# CLAREMONT COMMERCIAL FILING NO. 2

## "AMENDMENT" OF THE PRELIMINARY GRADING AND EROSION CONTROL PLAN

CLAREMONT COMMERCIAL FILING NO. 2			
PRELIMINARY GRADING AND EROSION CONTROL PLAN			
PROJECT NO. 44-037A	FILE: \\dwg\Eng Exhibits\44037-PGR01.dwg	DATE: 04-23-2020	
DESIGNED BY: GW	SCALE: HORIZ: 1"=60'		
DRAWN BY: CLP	VERT: N/A		
CHECKED BY: VAS		SHEET 1 OF 1	PGR01

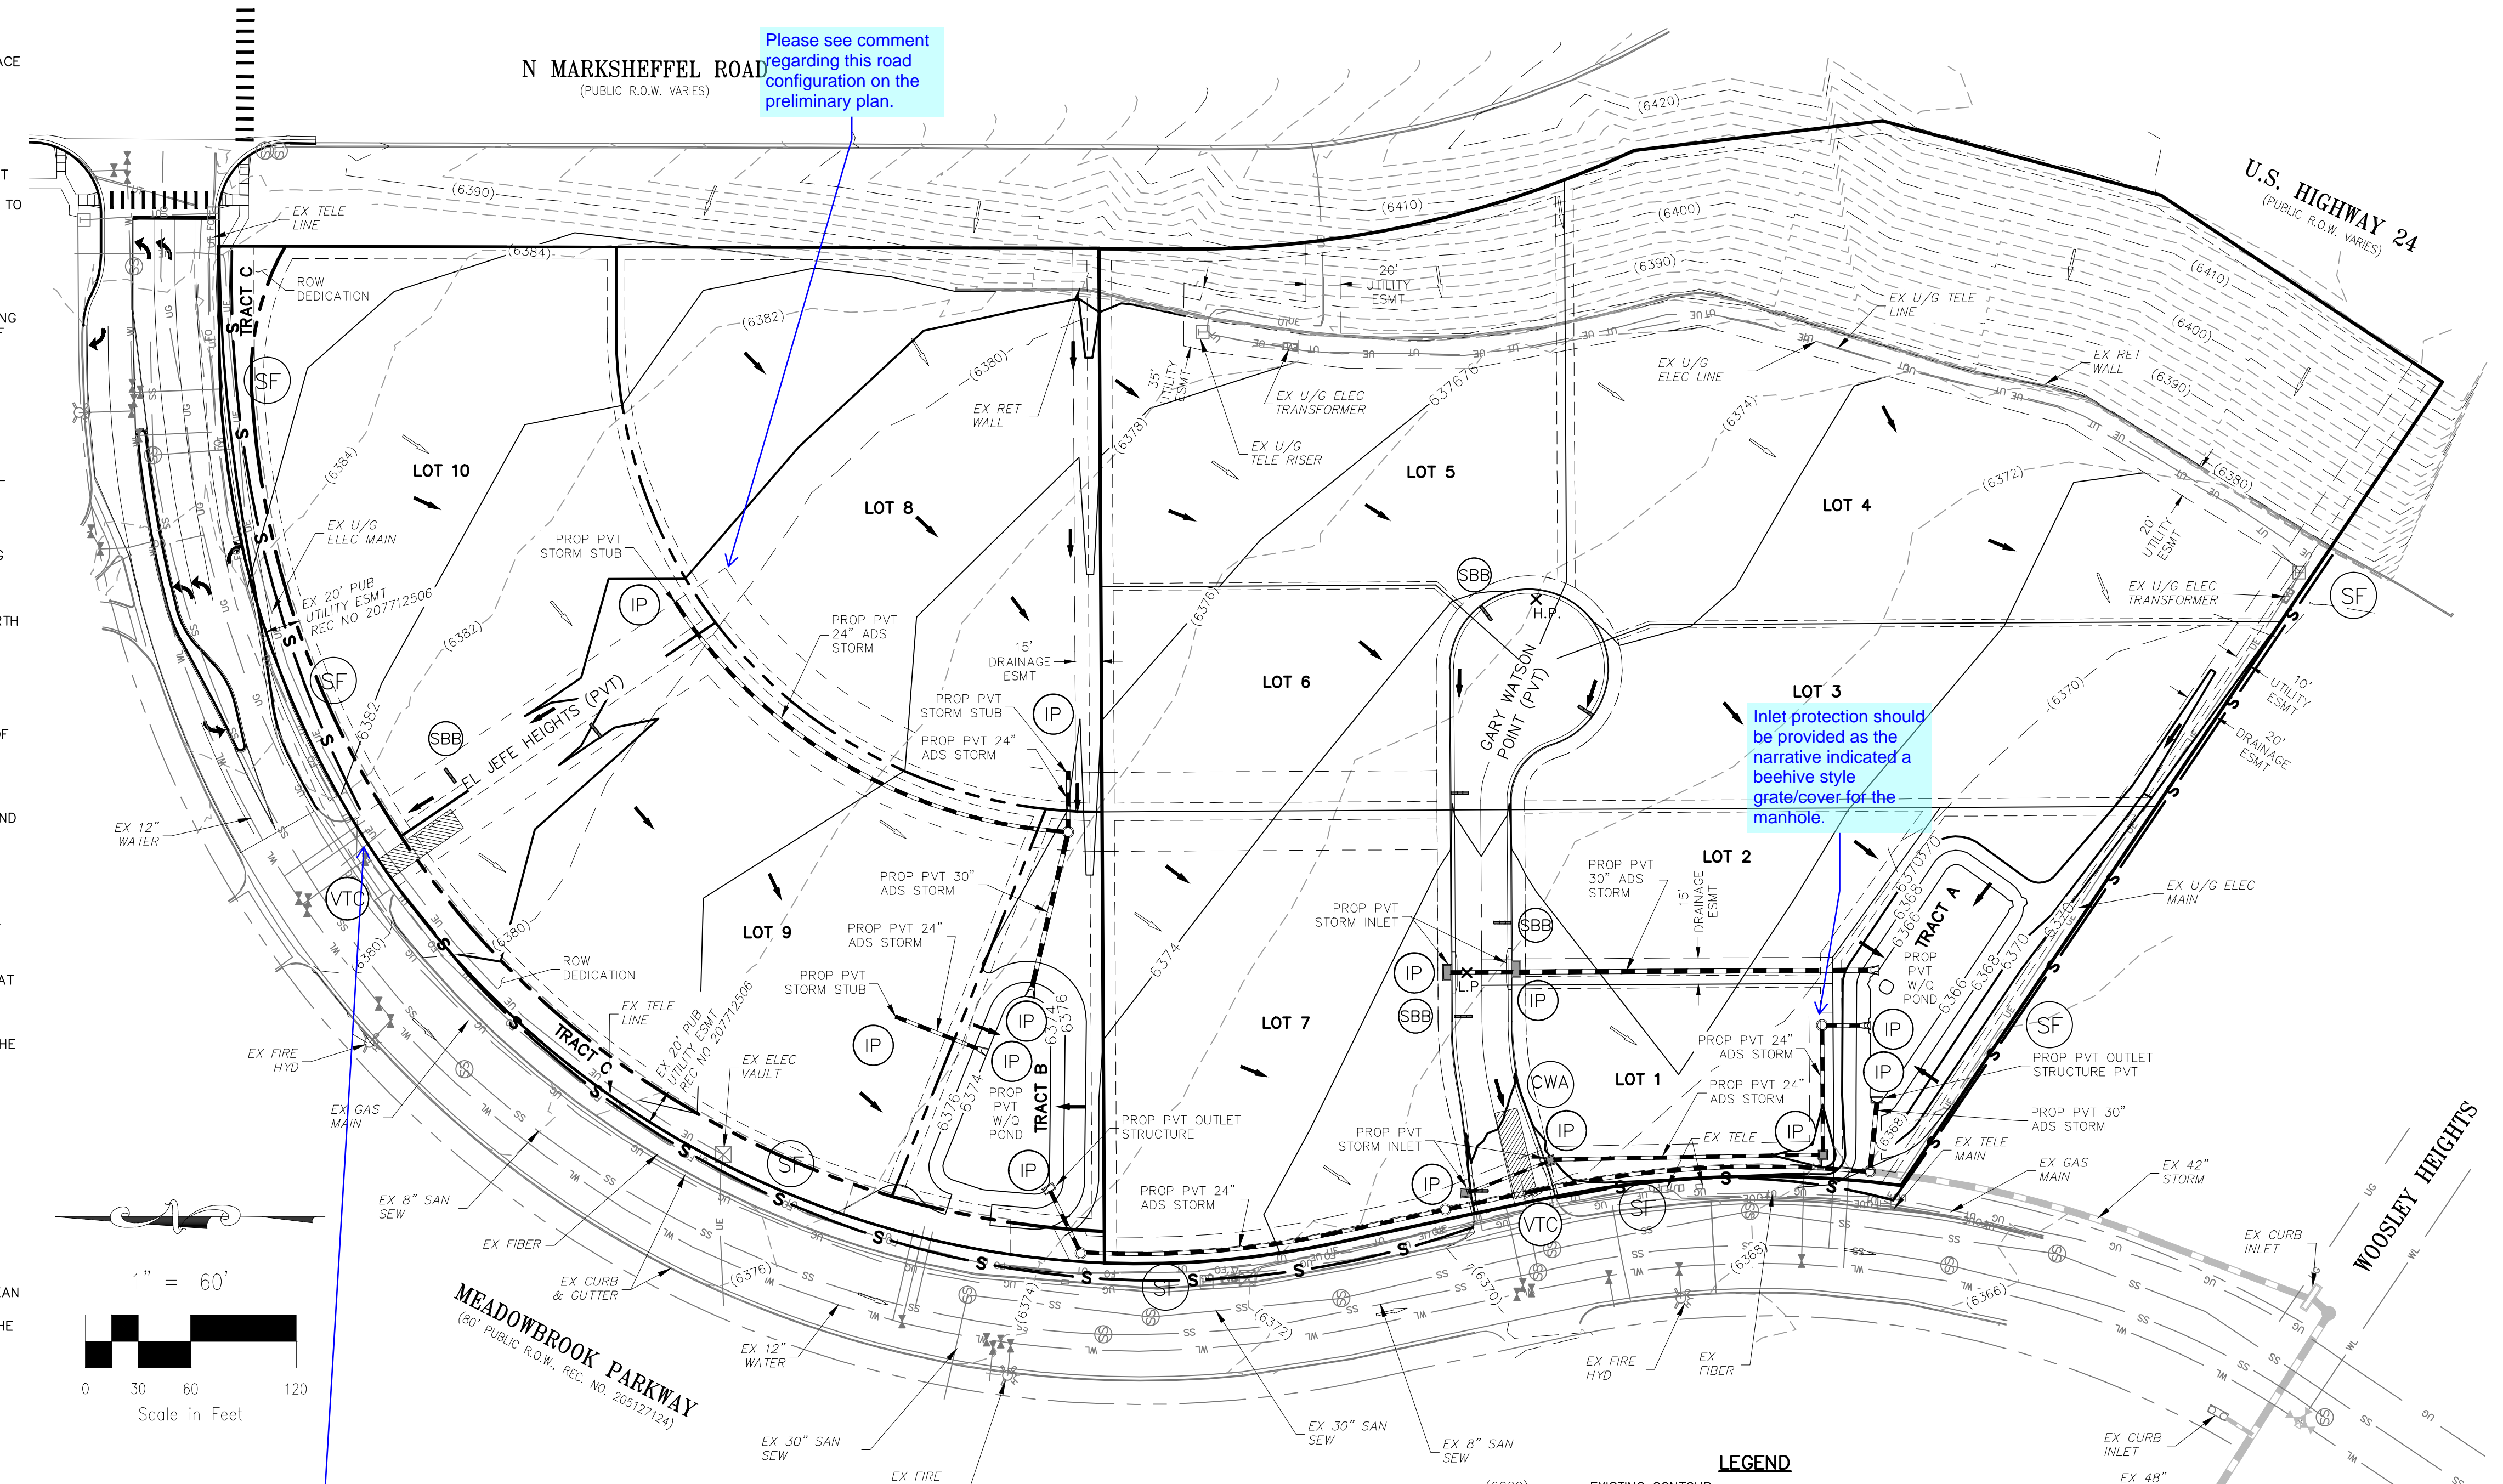
Please see comment regarding this road configuration on the preliminary plan.

Inlet protection should be provided as the narrative indicated a beehive style grate/cover for the manhole.

The traffic study recommended an exclusive right turn lane and a left turn/through lane at the intersection of El Jefe Heights/Meadowbrook. Please provide a cross section of this private road at that location also. The pavement width in the current cross section shown is not sufficient for the lanes required. Increase the width of the access easement if necessary.

Review 1 Comment: Add PCD File No. SP197  
 Review 2: Unresolved
